Reference: Lot E-2 Erie Air Park Tract E Minor Subdivision Replat A
2800 Airport Drive – Erie, Colorado

Reference: PUD and Minor Subdivision Comment Response Letter
PUD-001122-2019 and MS-001121-2019
Lot 1 – Erie Air Park Replat D
2800 Airport Drive – Erie, Colorado

The following is a line item response to the Town of Erie review comments dated January 29, 2020 for the above referenced project. The comments are listed below with responses in italics. Please let us know if you have any questions or need any further clarification regarding these issues.

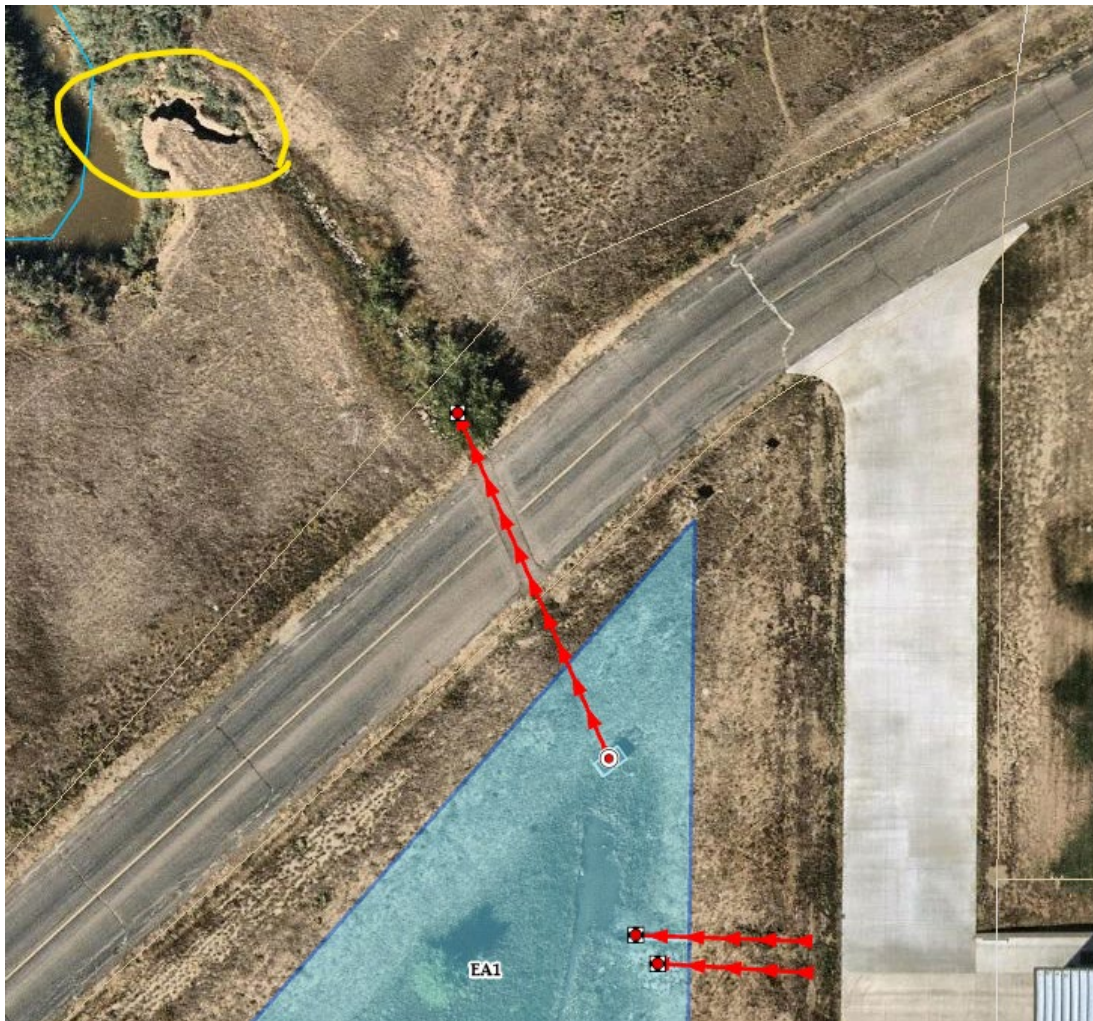
The mouth of the drainage swale/ravine that is to be used for outflows from the detention pond into Coal Creek is experiencing significant erosion – see aerial photos below. Review the current situation and provide the necessary stabilization measures to address the problem and prevent future erosion.

As you are aware, this section of Coal Creek was heavily damaged during the flooding event of 2013. The steep banks left after the flood have yet to be repaired, which has obviously been undermined and somewhat affected by our site drainage. We would be willing to discuss repair options as part of the broader repair project, or something more isolated in order to stabilize the offsite drainage. Any repair must be sensitive to permitting constraints.
